MEMO

Date: May 17, 2021

Re: 110-112 S. Riverview Street, First Demolition Review and Second New Construction Review

West (Front) Elevation

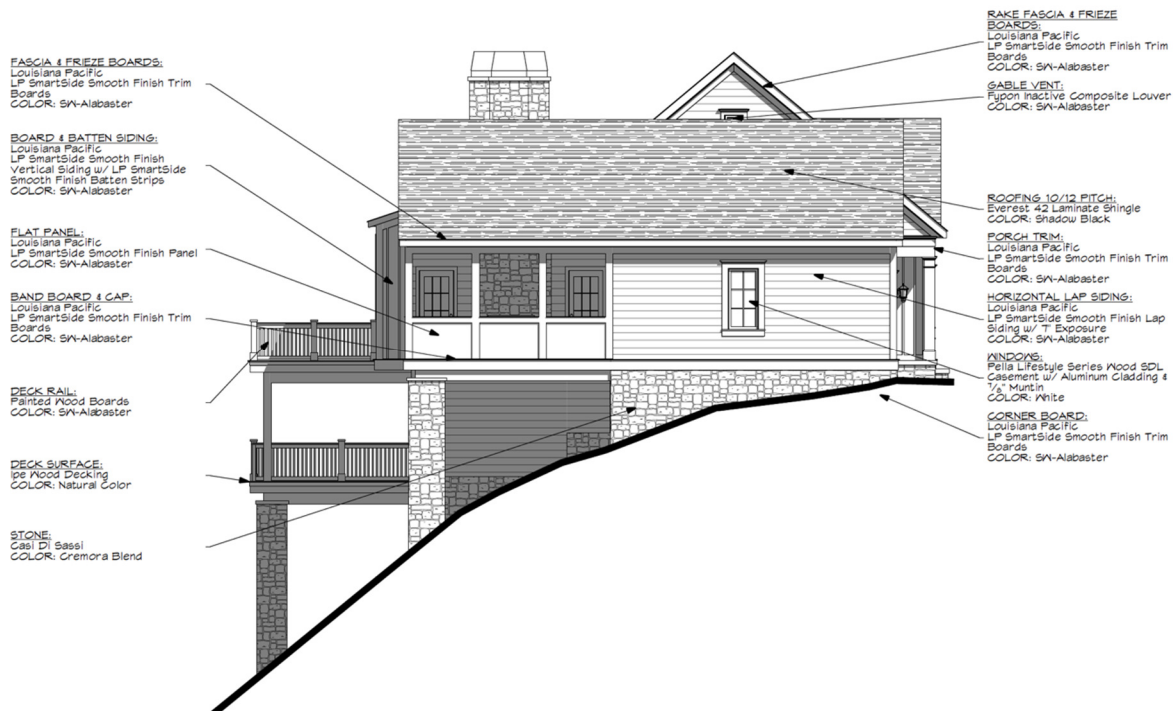
- Currently, the windows are listed as fixed or casement windows. Sash windows and horizontal siding are traditional to buildings in the historic district and would help maintain the historic context of the district. (This applies to all elevations.)
- Vertical board and batten siding should be reserved for outbuildings such as garages and hyphens (or connectors) to those outbuildings. Traditionally, it would not appear on the façade of a building. The vertical board and batten siding by the entry should be removed and replaced with horizontal siding more appropriate for the main house and compatible with other buildings in the area.

- Consider reducing the gable of the garage roof to give it less prominence (see sketch below). Traditionally, garages and other outbuildings were relegated to the rear of the property.

Sketch of revised west elevation with the “original” house on the right, its garage on the left, and the connector between them. This sketch uses an alternative massing design to consider. Sash windows are traditional to the area; consider changing the window type to double-hung. Note the simplified detailing around the windows and the entry porch.

North Side Elevation

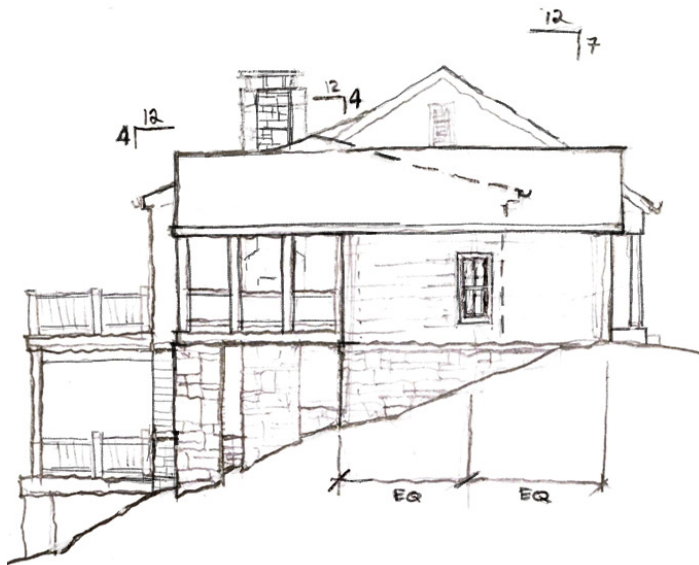
- The open porch chimney would traditionally extend to the ground. The Historic District Code Amendment 153.174 (i)(2) states, “Chimneys on exterior walls shall extend fully height from the ground.... Cantilevered and shed-type chimneys are prohibited.” This would help create a more uniform foundation along the lower level (see sketch below).

- On the open porch, consider raising the bottom of infill railing panels to provide a <4” gap from the porch flooring, and extending the flooring out slightly over the band board. This detail is traditional and would have allowed water pooled on the open porch to drain.
- Remove the cantilever for the rear portion of the kitchen and living and dining rooms or extend the lower level out to match the wall above. Traditionally, this area would not be a cantilever but part of the main house with a solid foundation.

Sketch of revised north elevation using the alternative massing. The “original” house and its garage have one matching roof slope while the connector and the rear addition have a different matching roof slope. Note that the open porch’s chimney continues to the ground. The rear cantilever is removed, making both levels flush.

South Side Elevation

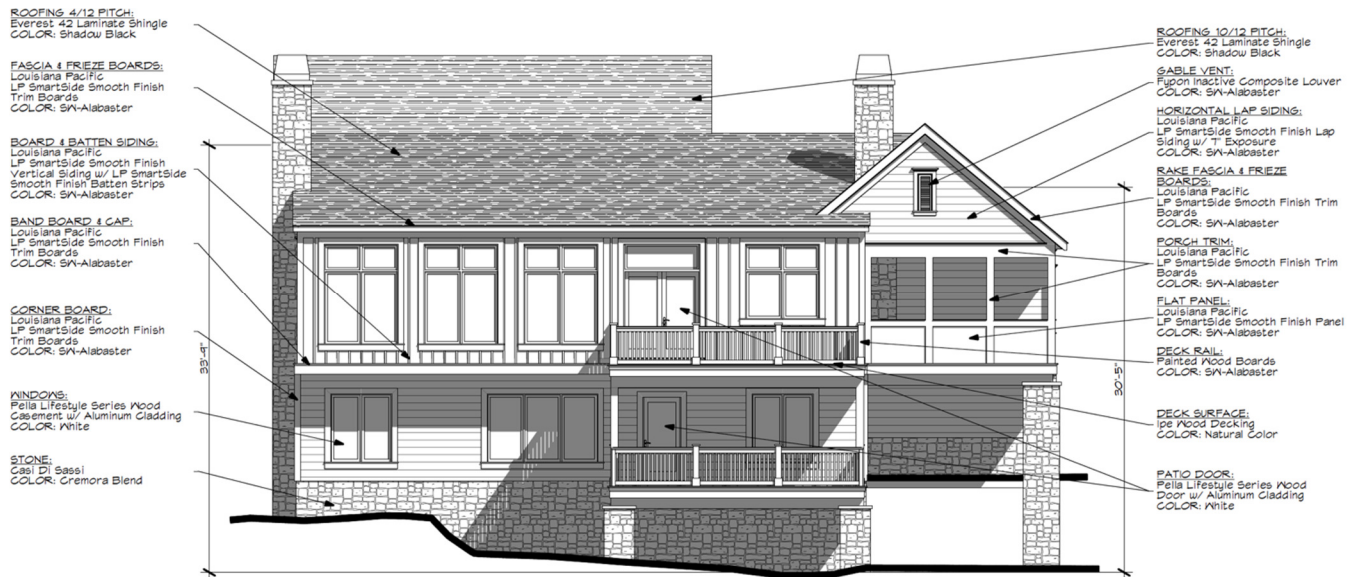
- The southern chimney’s position appears out of place and should read as part of the main house, not an afterthought or addition. Consider the massing alternative (see sketch below) as it places the chimney on the wall of the “original” house (before the eave).

- Remove the cantilever for the rear portion of the kitchen and living and dining rooms. Traditionally, this area would not be cantilevered. In addition, this area should have the same horizontal siding of the main house and not vertical board and batten, which traditionally appeared in outbuildings.

Sketch of revised south elevation with continuous stone foundation, and horizontal siding; this sketch uses the massing alternative at the end of this report. Making the rear building element an “addition” could reduce the amount of stone foundation on that portion only. Note that the lower level window needs to be compatible in size and type to the windows above.

East (Rear) Elevation

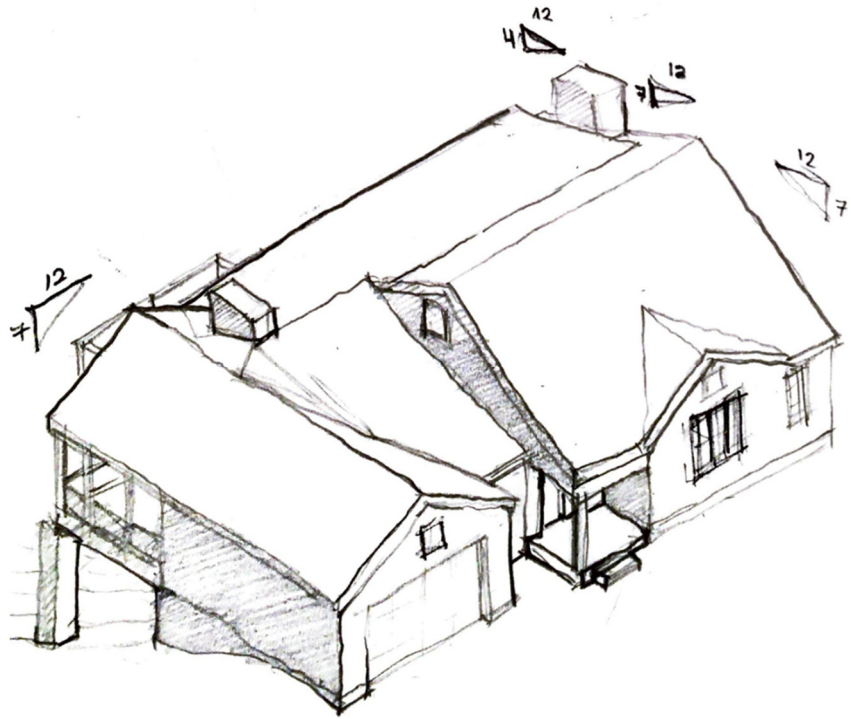
- Although a rear elevation, the windows should match those on the front of the house, preferably sash windows, to create a cohesive structure (see sketch below).
- Remove the cantilever for the rear portion of the kitchen and living and dining rooms. Traditionally, this area would not be a cantilever but part of the main house with a solid foundation. In addition, this area should have the same horizontal siding of the main house and not vertical board and batten, which traditionally appeared in outbuildings.
- The chimney stack for the fireplace in the sunroom should extend all the way down to the ground plane.

Sketch of rear elevation based on the alternative massing option. (Note the continuous stone foundation on the “original” house and garage and a lowered stone foundation on the “addition.”) Elsewhere is horizontal siding. The “addition’s” window should be the same type as on the “original” house (double-sashed), and both chimneys should have more simple caps. Note that the open porch’s chimney continues to the ground.

Diagrammatic sketch of north and west elevations.

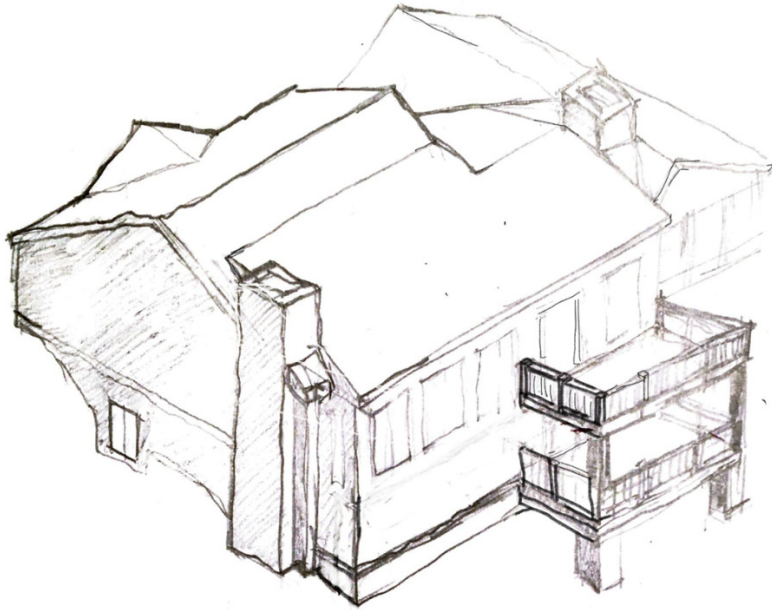
One option to resolve some of the massing and composition issues with the rear of the structure is to view the building as if it grew over time. The main portion of the house could be considered the “original building” while a “hyphen” (the powder room and mud room) connects it to the garage outbuilding. The kitchen, dining and great room areas could be a later “addition.” This alternative massing option separates out an “addition” and a “connector” from the “original” house and garage, thereby containing elements of a “later date.” For example, the “original” house would have older elements, such as having a stone foundation around the entire lower level. Any “addition” to this building could have a later element, such as reducing the stone foundation to allow more horizontal siding on this lower level (see sketches below). The roofline of the whole structure should follow this pattern as well, with the roof of the main building being predominate and the others appearing as shed-roof additions (see sketches below).
